TOWN OF COVENTRY, RI  
DEPARTMENT OF PLANNING & DEVELOPMENT

## STAFF REPORT

<b>Project Name:</b>	<b>Harkney Hill Office/Storage Units</b>
<b>Plan Type:</b>	Unified Development Review (Major Land Development w/ associated Dimensional Variance)
<b>Plan Review Phase:</b>	Preliminary Plan
<b>Owner:</b>	AJB Real Estate, LLC
<b>Applicant:</b>	Andrew Barber
<b>Address:</b>	71 Harkney Hill Road
<b>Plat / Lot / Zone:</b>	<b>AP 10 Lot 42 Zone GB-1 Lot Size 2.2 acres</b>
<b>Existing Use:</b>	Vacant
<b>Proposed Use:</b>	Commercial office and equipment storage buildings
<b>Description:</b>	Applicant proposes to develop one commercial office building and two equipment storage buildings for contractor use, with development occurring in phases. The applicant is seeking zoning variances for the building design elements proposed for this site (which is located within a Special Planning Overlay District) and therefore will be heard via Unified Development Review.

### TECHNICAL REVIEW COMMITTEE REPORT

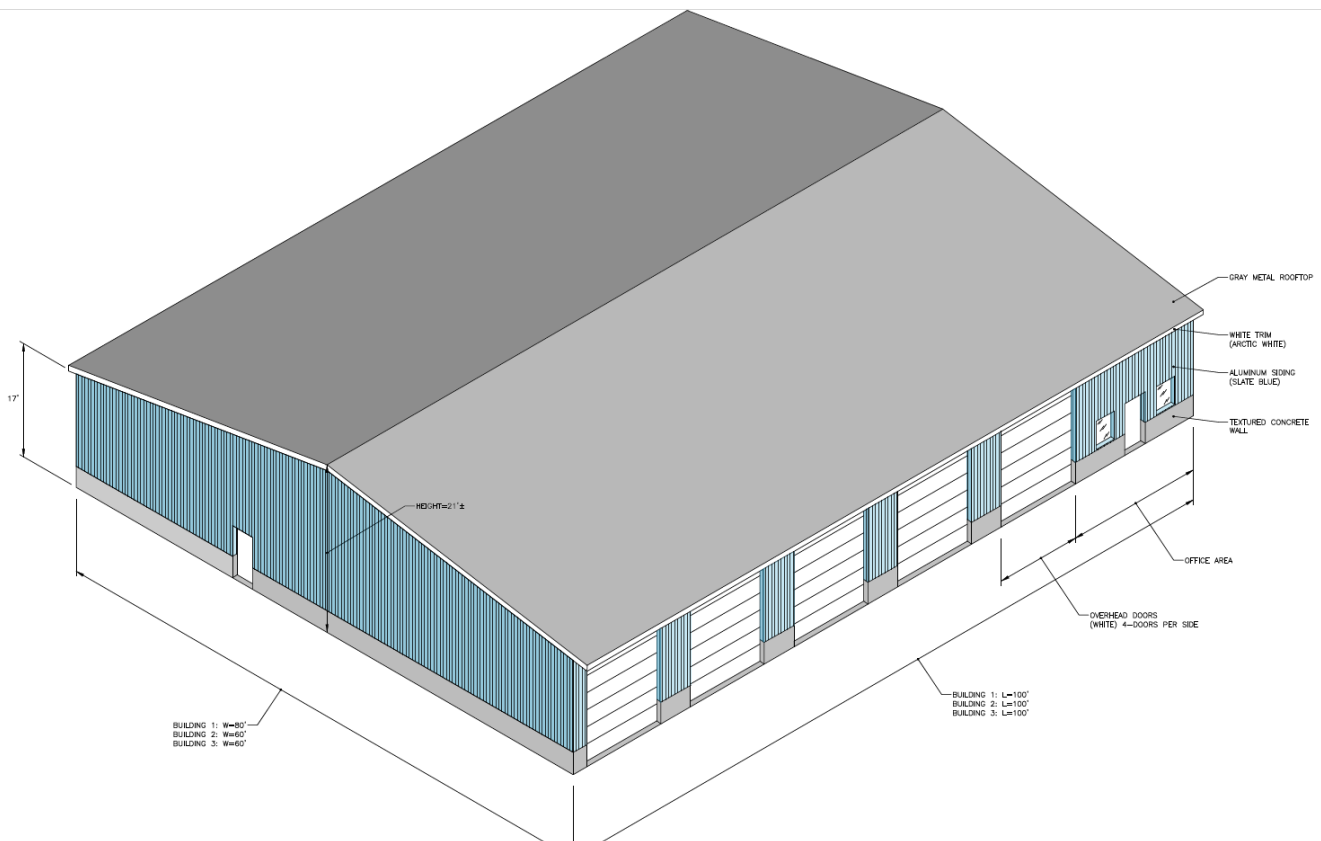
In response to both required standards, the applicant listed “Metal siding with overhead doors (building is blue in color).” Based on supplementary materials, Staff understands the applicant intends to purchase and install the same model of prefabricated metal building with aluminum siding from Olympia Steel Buildings. The 8,000 SF “Phase 1” building would be 80 feet wide, while the two 6,000 SF “Phase 2” buildings would be 60 feet wide; all three buildings would be 100 feet long.

The isometric view below shows the shade of blue (“slate blue”) the applicant intends to select as the color for all three buildings; note as well the white trim around the roof and the textured concrete hip wall along the base.

Per Section 255-V-530E(2)(e)[1] of the Zoning Code, “There shall be no blank, windowless uninterrupted facade in excess of 60 feet in length. Lengthy facades shall be interrupted by recesses, projections, windows, awnings or similar measures.” The rear wall of both 6,000 SF buildings – the 100-foot-long side – lacks windows and doors. The applicant did not request relief for this section of the Code; instead, the applicant indicated in an email dated April 13, 2025:

In a comment provided at the April Technical Review Committee meeting, Staff also encouraged the applicant to incorporate non-metal exterior materials, such as wood, brick, stucco, sandstone, or nature stone, into all facades facing public rights-of-way across the three proposed buildings. For example, the applicant may wish to consider cladding the proposed textured concrete hip wall in one of the materials named above.

As these rear walls will be the buildings’ least visible facades, and windows would therefore add little aesthetic value in practice, Staff would support granting dimensional relief for 255-V-530E(2)(e)[1] in lieu of a Condition of Approval requiring windows to be cut into the walls.
